South Texas Project Electric Generating Station P.O. Box 289 Wadsworth, Texas 77483

May 12, 2010  
U7-C-STP-NRC-100089

South Texas Project  
Units 3 and 4  
Docket No. PROJ0772  
Response to Requests for Additional Information

Figure 1 Examples of valid component connection

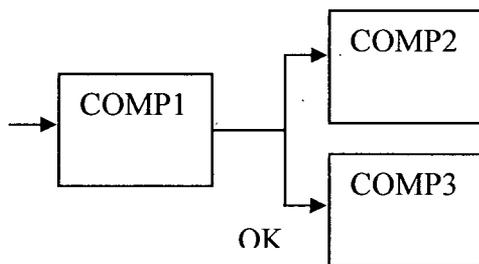
Section 3.11 of Supplement 3 states that a signal can only be connected to one single output. There may be measured plant signals for a plant-specific configuration that is used for multiple control system inputs. Please describe how such a configuration is modeled in SAFIR. As appropriate, please provide a specific example to assist the staff in understanding the approach taken.

A SAFIR component calculates an output signal that has to be unique within the SAFIR model, i.e. there may not be two identically named output signals. The signal flow is from an output connection to one or several input connections. An output signal may be connected to several input connections to components as shown in Figure 1 below. A signal may not be calculated by more than one component as shown in Figure 2.

Figure 1 **PID controller composed of SAFIR AMP, INT and DERIV**

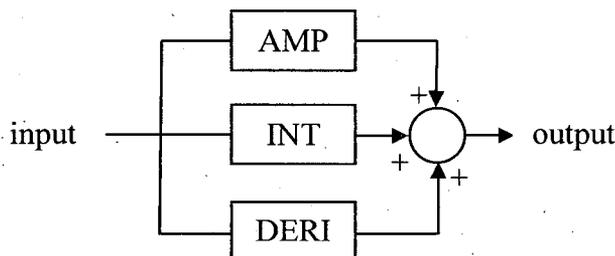
Among the available SAFIR components described in WCAP-17079-P Table 3-2 are ones labeled as PIP (Proportional Integrating Proportional) and PDP (Proportional Derivating Proportional). Are PIP and/or PDP controllers used in the SAFIR input model for ABWR? If so, then:

- Are PIP and PDP controllers used in the SAFIR model of ABWR? If so, then provide a reference on the technical basis (i.e., theory) and application of these controller types.
- Why does the SAFIR component list (i.e., Table 3-2 of WCAP-17079-P) not include a standard PID (Proportional-Integral-Derivative) controller? Are any PID controllers present in ABWR systems to be modeled using SAFIR? If so, then describe how they would be modeled in SAFIR.

The PID controller was not part of the selection of components during the development of SAFIR (based on a predecessors to the current Westinghouse Advant Controller family), and there has not been any request or need for a PID controller in any of the SAFIR models built as today. If a need for a PID function arises, the PID controller can be composed by combining the INT, AMP and DERIV components in SAFIR as shown in Figure 1.
